Intel® Itanium® Architecture Software Developer's Manual Specification Update

November 2003

Document Number: 248699-008

Figure 13-3. Correctable Machine Check Code Flow

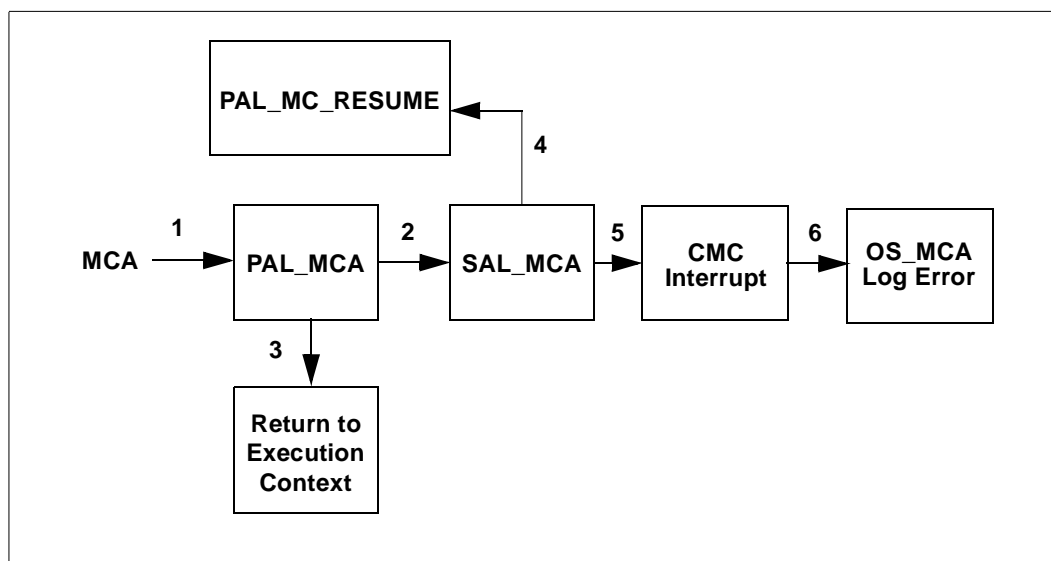
- b. Added correctable machine check flow:

Figure 2-3. Version Information in Registers EAX

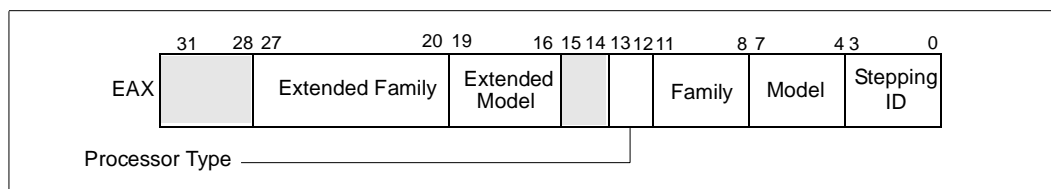
When the input value is 1, the processor returns version information in the EAX register (see [Figure 2-3](#)). The version information consists of an Intel architecture family identifier, a model identifier, a stepping ID, and a processor type.
